**Architectural Review Board Staff Report
October 13, 2025 Meeting**

**CERTIFICATE OF APPROPRIATENESS
6600 NEW ALBANY-CONDIT ROAD I-PUD REZONING**

LOCATION: 6600 New Albany-Condit Road (PID: 222-000640)
APPLICANT: Rob Riddle c/o Aaron Underhill, Esq., Underhill & Hodge LLC
REQUEST: Certificate of Appropriateness
ZONING: Urban Center Code to Infill-Planned Unit Development (I-PUD)
STRATEGIC PLAN: Village Center
APPLICATION: ZC-78-2025

Image: Proposed traditional commercial storefront, which is recommended by the Village Center Commercial Design Guidelines and Regulations.

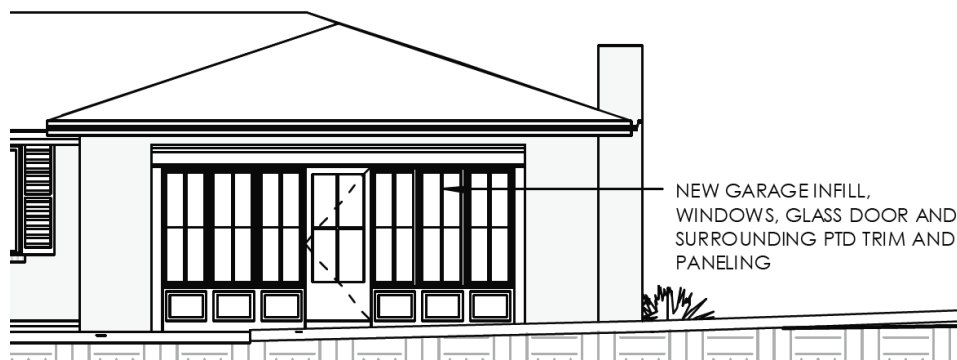
- A traditional commercial storefront (e.g. display windows, bulkheads) will be installed where the garage doors are currently located on both the main building and accessory building; the storefront is recommended by the Village Center Commercial DGRs. This supports compliance with the commercial DGRs while still retaining the residential character and original qualities of the buildings.

1. The main characteristics of the buildings and site are already existing and will remain in place. The new garage infill follows commercial storefront design elements that are recommended by the DGRs for commercial buildings in the Village Center. The modifications nonetheless retain and are sensitive to the existing residential character of the buildings and context with adjacent rural residential sites.

Image: Site plan as proposed in the preliminary development plan.

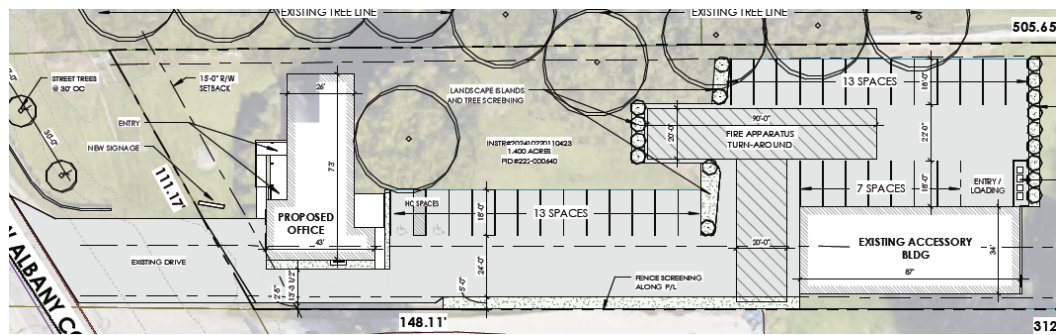
1. Landscape islands and tree screening are proposed around the parking lot. Plantings are shown in the preliminary development plan around the pedestrian walkways leading to the main building. Whether the trees in the right-of-way of State Route 161 will remain is contingent upon the construction of the noise wall.
2. New vehicular circulation is proposed within the interior of the site, and access to the lot from the right-of-way is to remain the same. The new vehicular circulation includes access to new parking spaces throughout the site, a fire apparatus turn-around area, and an entry and loading area to the accessory building. Pavement widths for vehicular movement are generally 20 to 24 feet in width except along the south side of the main building, which provides 13 feet and 3.5 inches of width.

3. Pedestrian circulation internal to the site is facilitated by new sidewalks on the front and back of the main structure; the front includes both a ramp and stairs for access to one of the front entries.
4. See the lighting and signage sections of this staff report under parts E and F of "Proposed I-PUD Zoning Text Regulations."
